NEW
RIVER

Burgess Hill

Design & Access Addendum

Proposed Section 73 Amendments

2.4 General Layout/Plan Changes

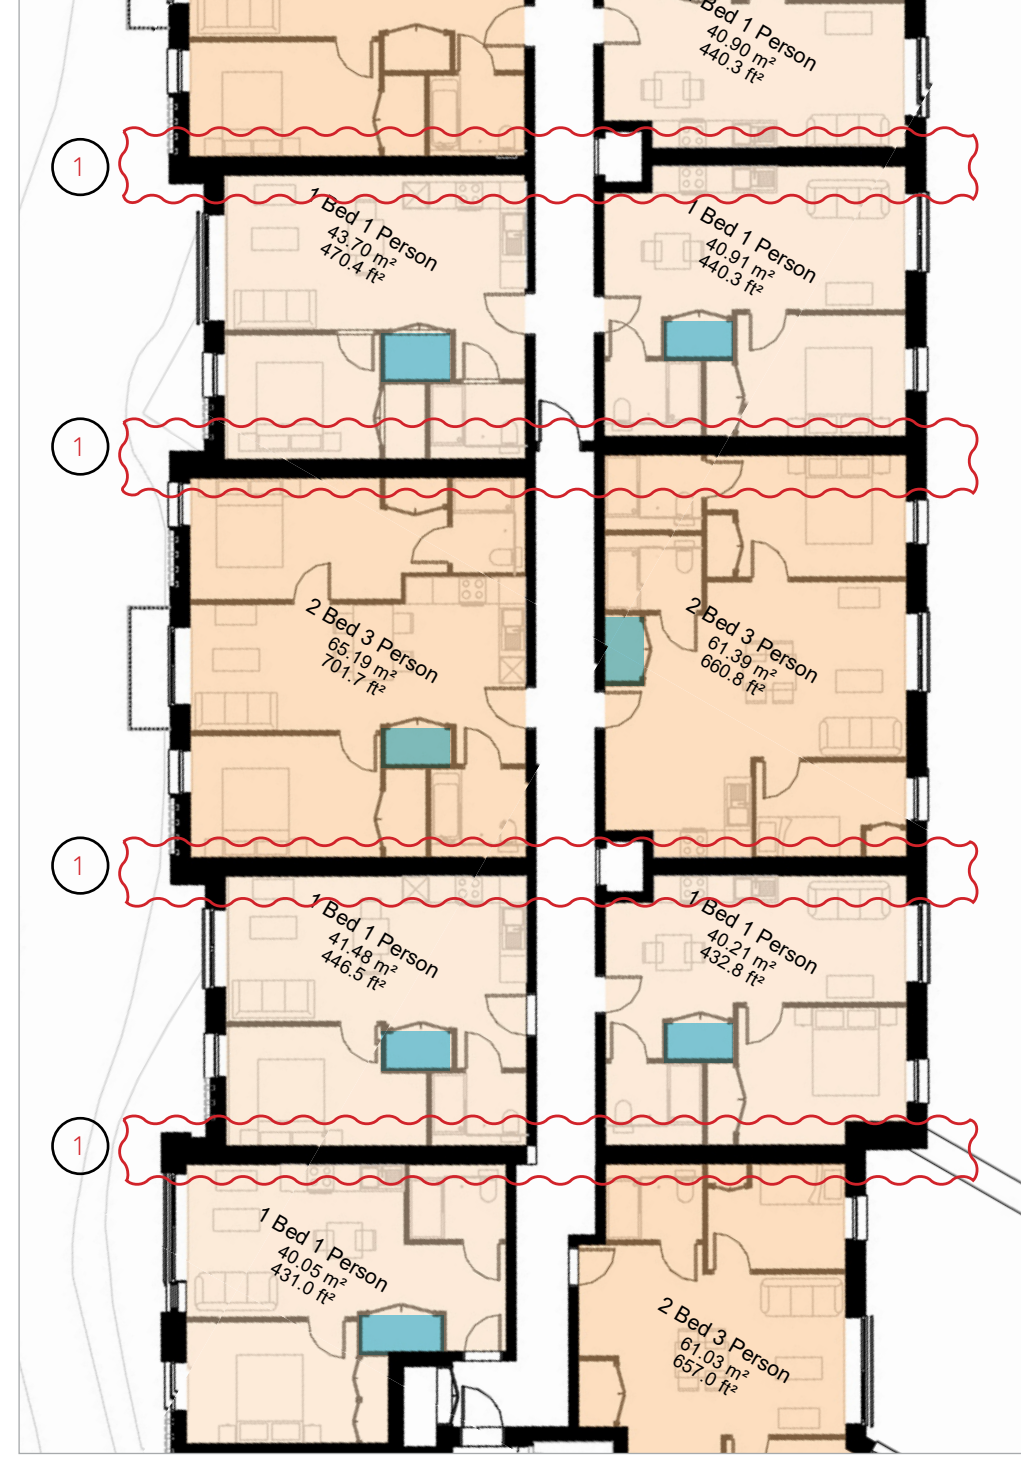
- 1. Internal and external walls increased in thickness to accommodate structure and satisfy thermal requirements.
- 2. Bedroom and living room sizes standardised to better satisfy national housing space standards
- 3. Utility space in all flats standardised to 1500mmx800mm.

Proposed Basement Floor Plan - Block A1

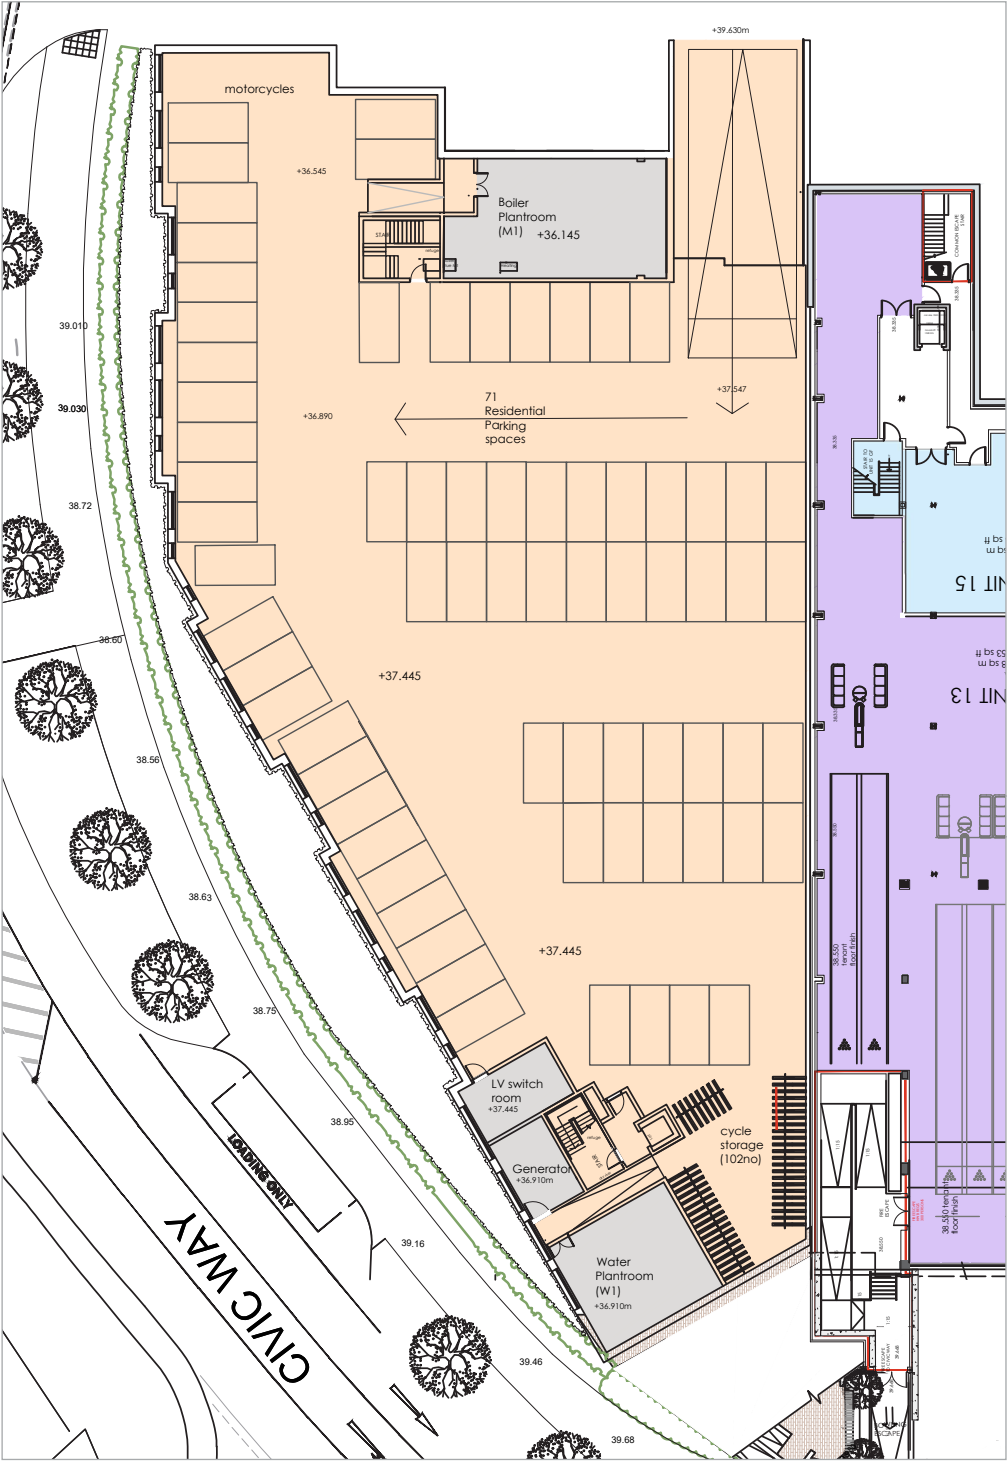
- 1. Bin store split into two stores to ensure all flats are within 30m horizontal travel distance of a waste/recycling disposal point
- 2. Cinema/Gym Space Adjustment to accommodate second stair in tower element of the scheme.

Proposed Lower Ground Floor Plan - Block A1

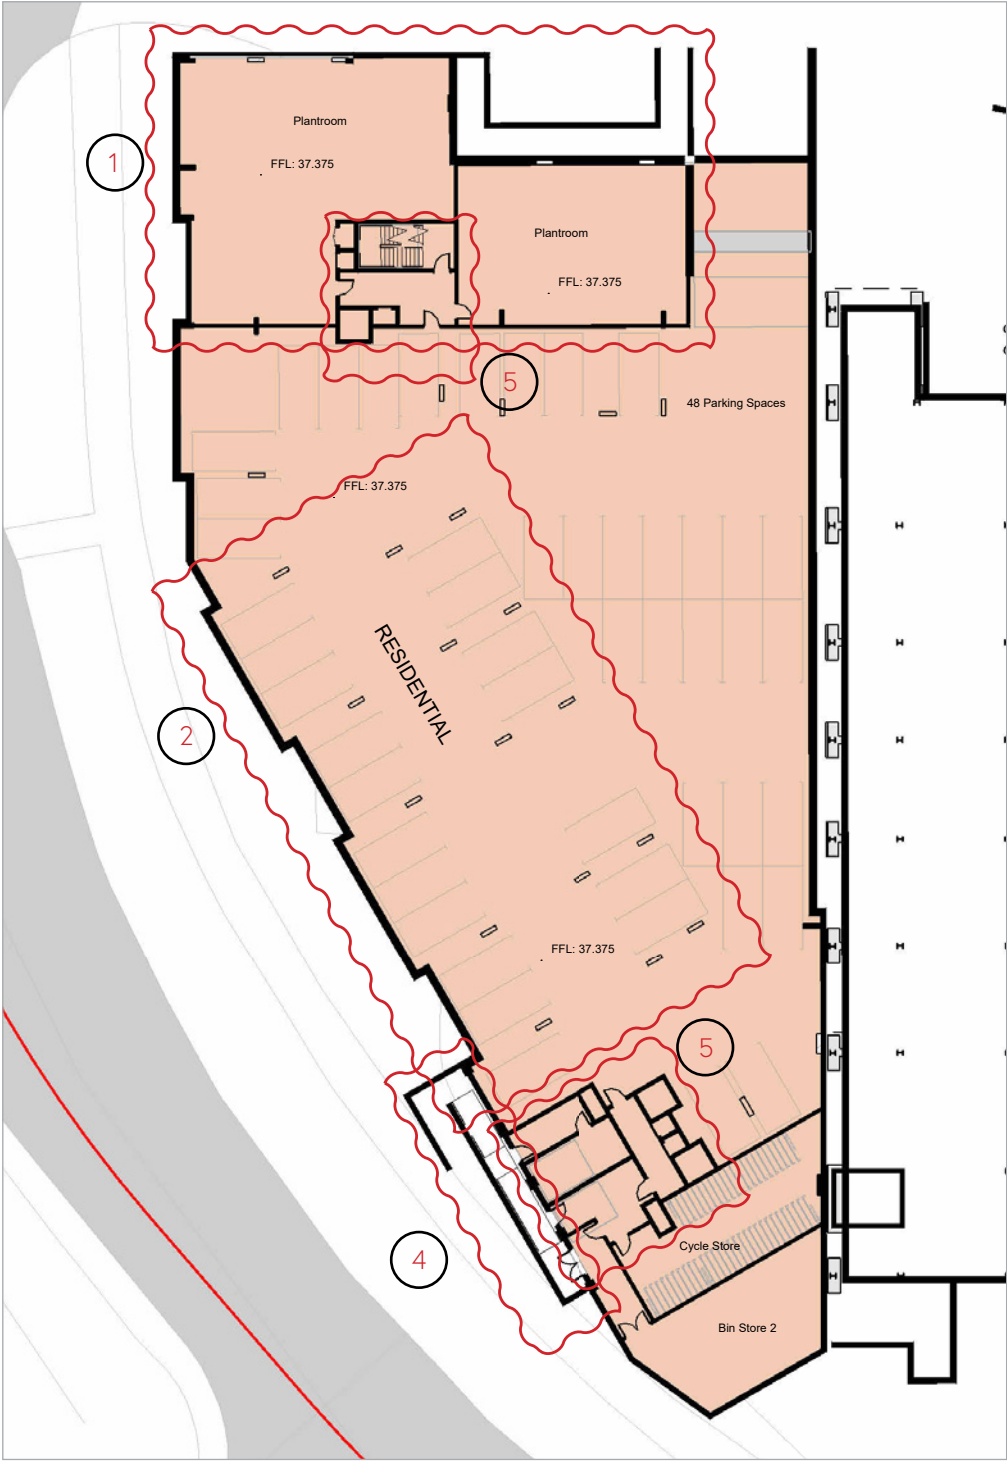
- 1. Increased Plant Zones allocated to allow for increased sprinkler tank requirements including a commercial grade sprinkler system for the basement car parking given the requirement for passive EV charging to all parking spaces.
- 2. LG car park layout revised to accommodate structure.
- 3. In the consented application there were 71 spaces in the lower ground floor level of the residential block, in the revised proposal this has reduced to 48 spaces. 23 residential parking spaces have been relocated from the lower ground level of the residential block to the external car park adjacent to Civic Way to ensure total number of spaces remains unaltered.
- 4. Pedestrian and cycle ramp, for entrance and egress to LG, added to Civic Way West elevation.
- 5. Lobbies to bin stores and stair cores amended, added, and increased in size to meet fire strategy requirements.

3.2 Bowling Alley Relocation

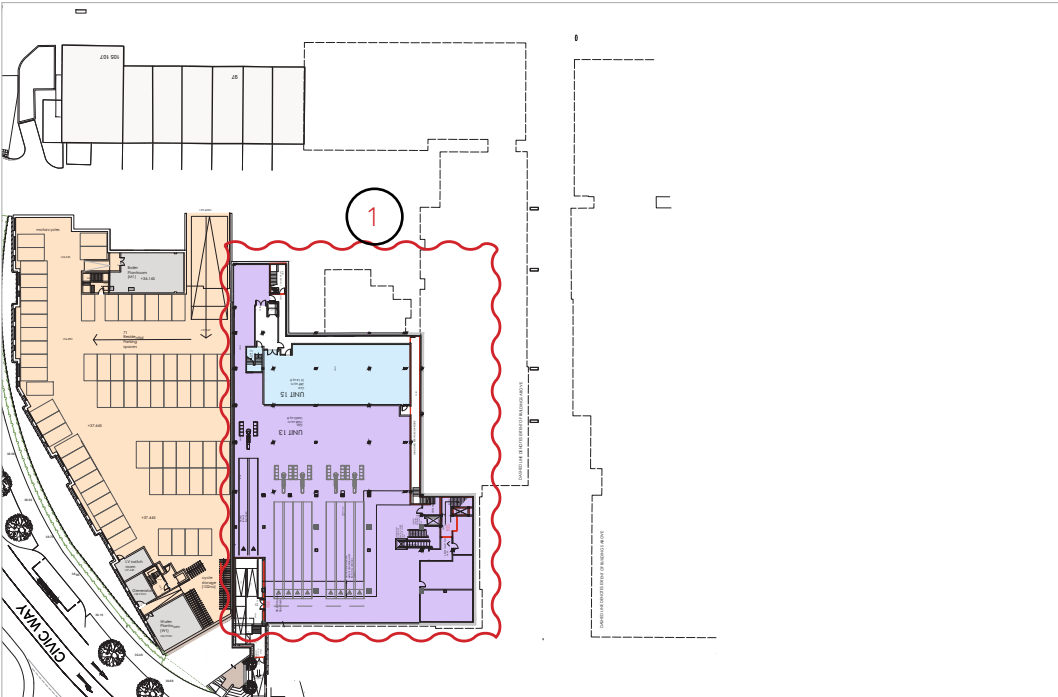
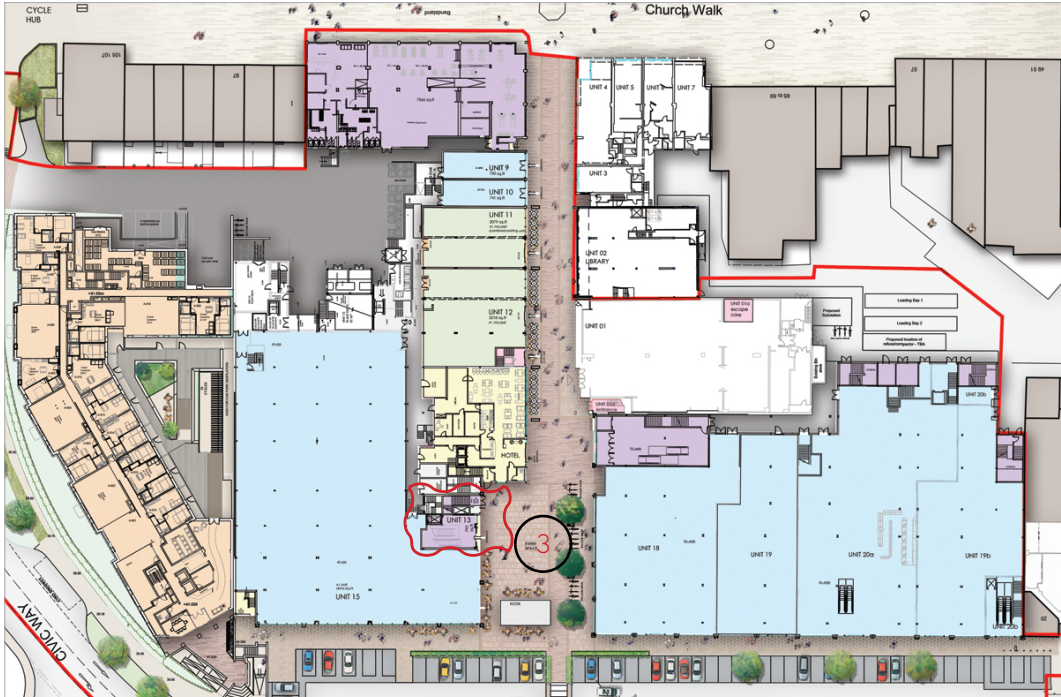
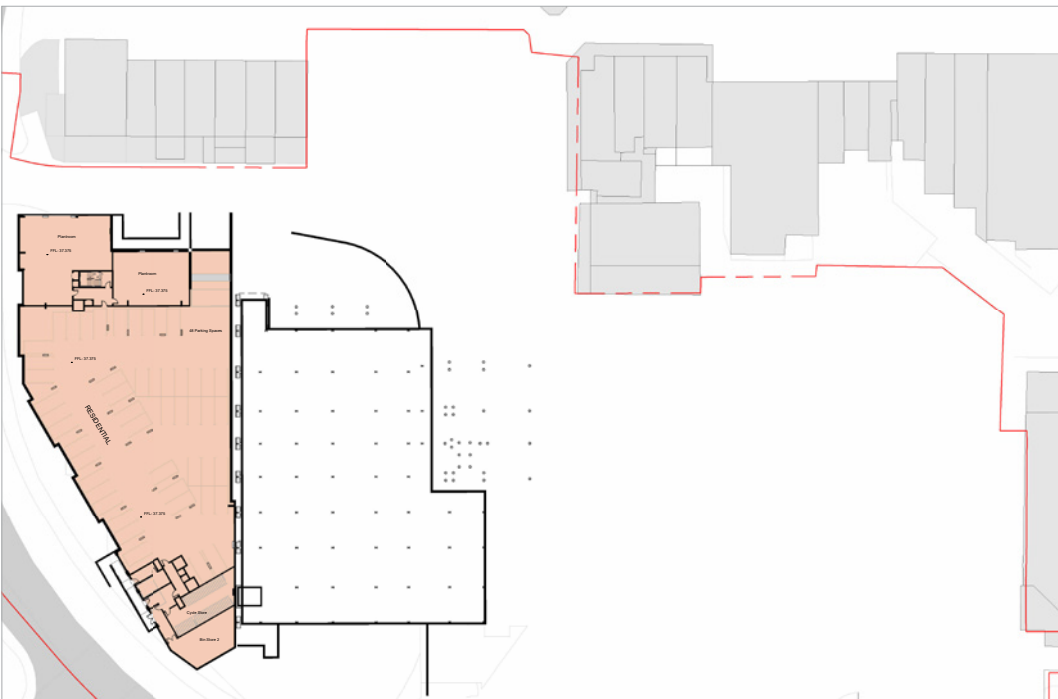
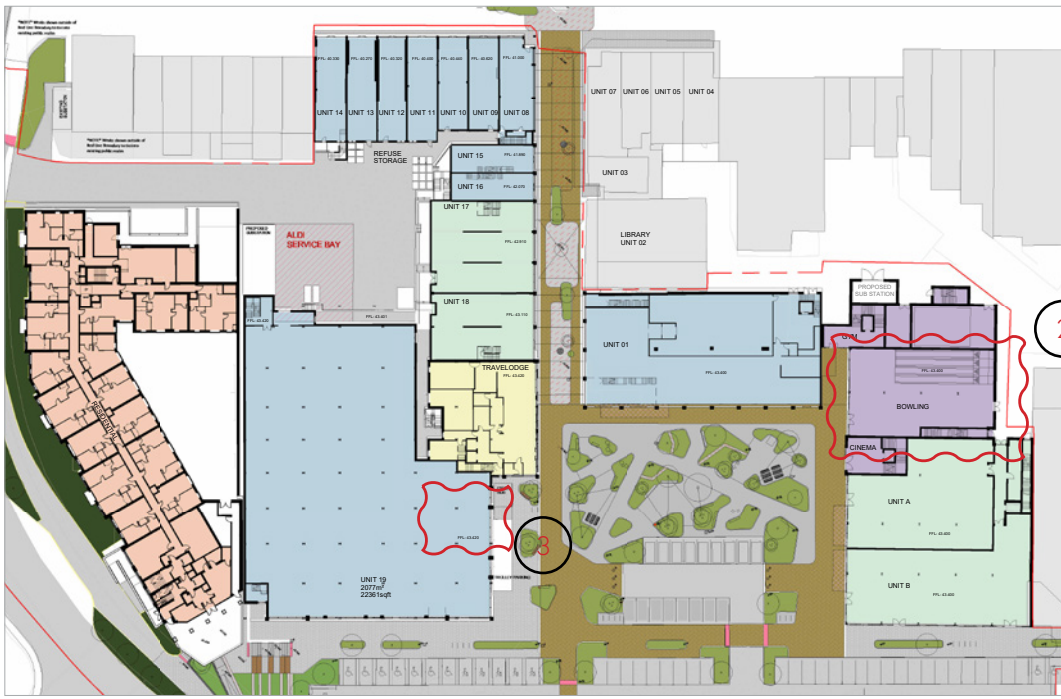
- 1. The proposed conversion of the Basement (Level 00) below the proposed Food store has now been omitted from proposed Block A2.
- 2. The basement was previously allocated for Leisure Use as a Bowling Alley, numbered as Unit 13. The proposed Bowling Alley (previously Use Class D2 now Use Class E) has been relocated within the Leisure Block - refer to Block B. The basement space, which is a result of the site's topography, will be left voided and will be enclosed.
- 3. The ground floor entrance to the Bowling Alley, from the external event space, and the associated second fire exit into the service yard are no longer required, and the footprint of those areas is absorbed into the proposed Food store (previously Unit 15).

3.3 Service Yard Amendments

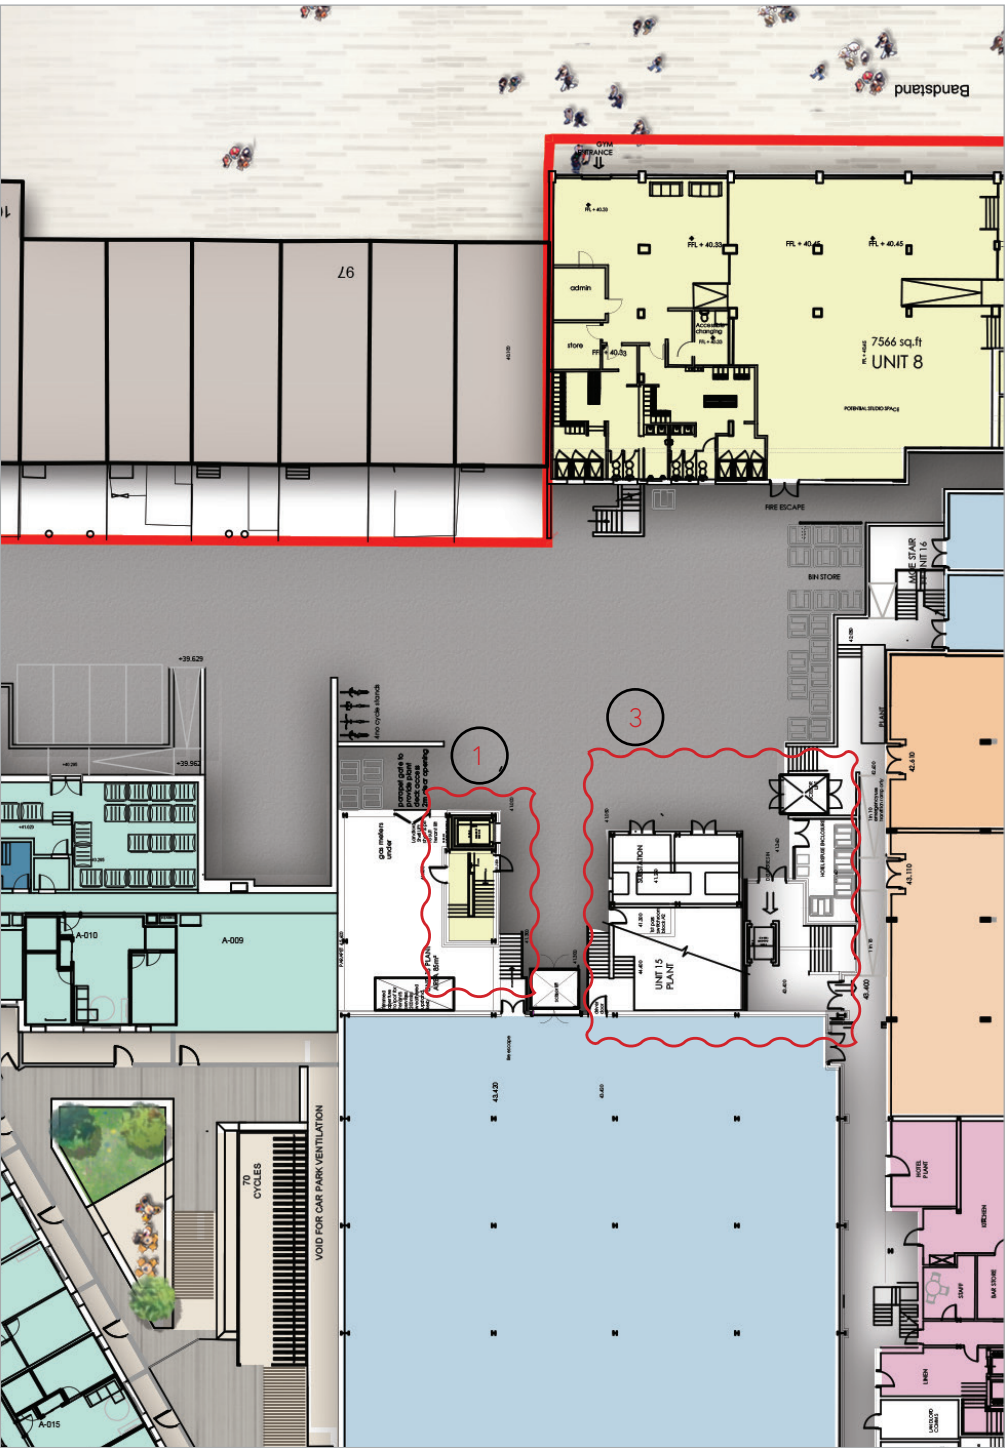
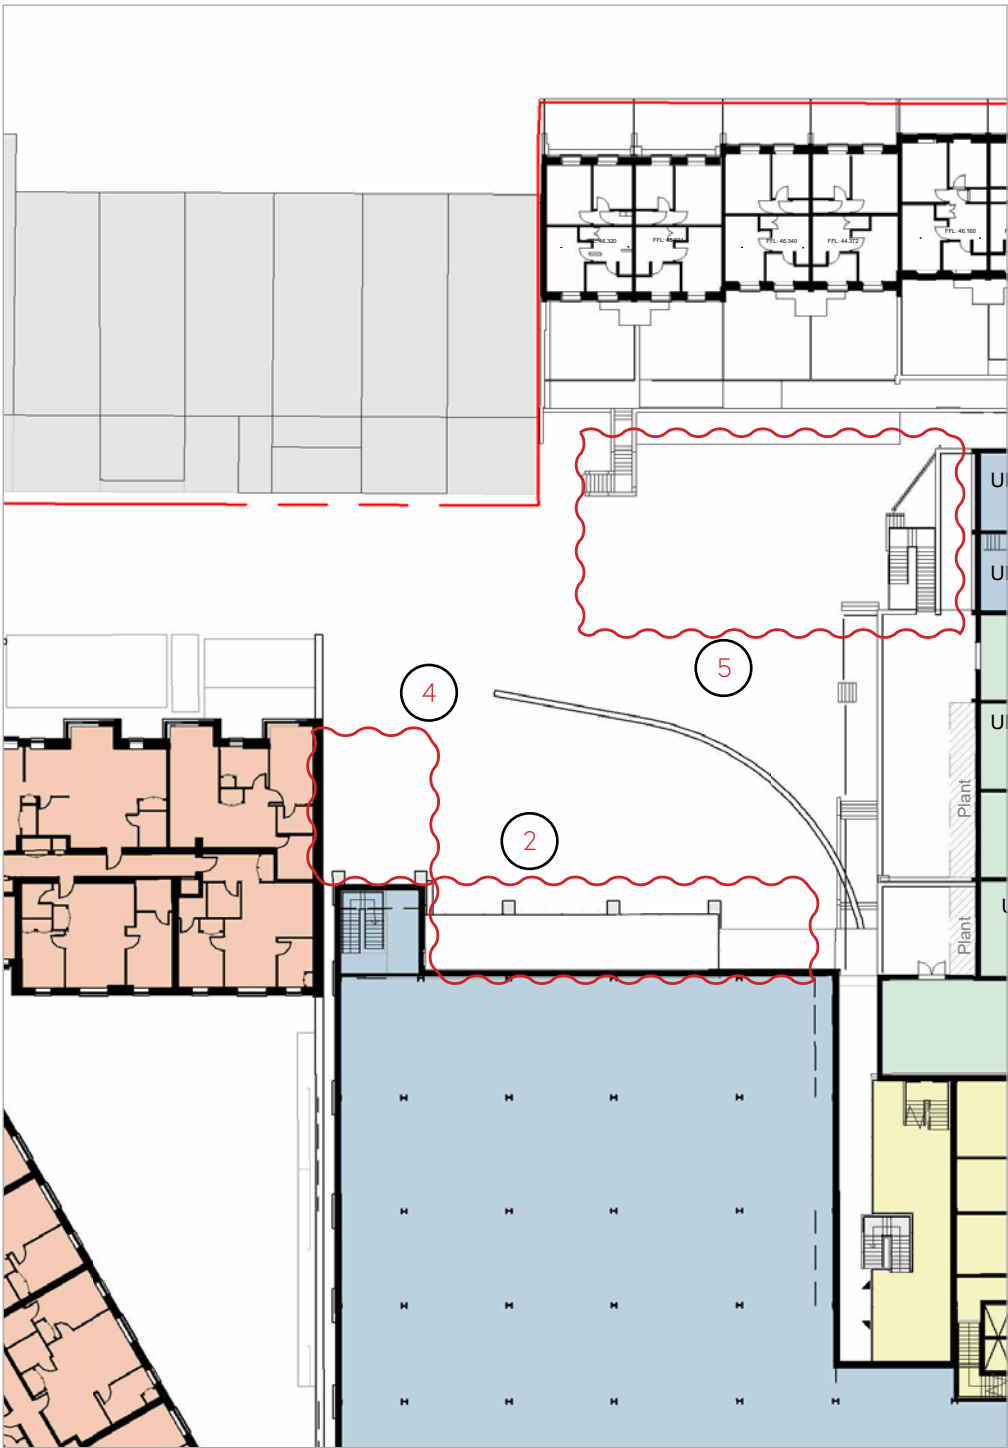
- 1. Omission of basement level access simplifies the external ground levels required and in turn the serviceability of the service yard.
- 2. Ground level in the service yard adjusted to facilitate the loading bay sitting level with both Aldi and Travelodge ground floor levels.
- 3. Stairwell and lift connecting the service yard and rear access to the Hotel are omitted as level access is now provided for all deliveries.
- 4. Sub-Station relocated to the boundary with the Residential Block (A1). Following engagement and calculations a double sub has been confirmed.
- 5. Following the re-design of the service yard, tracking of vehicular movements, revisions to the proposed buildings and changes to the external levels necessitates a re-design of the refuse storage in this area.
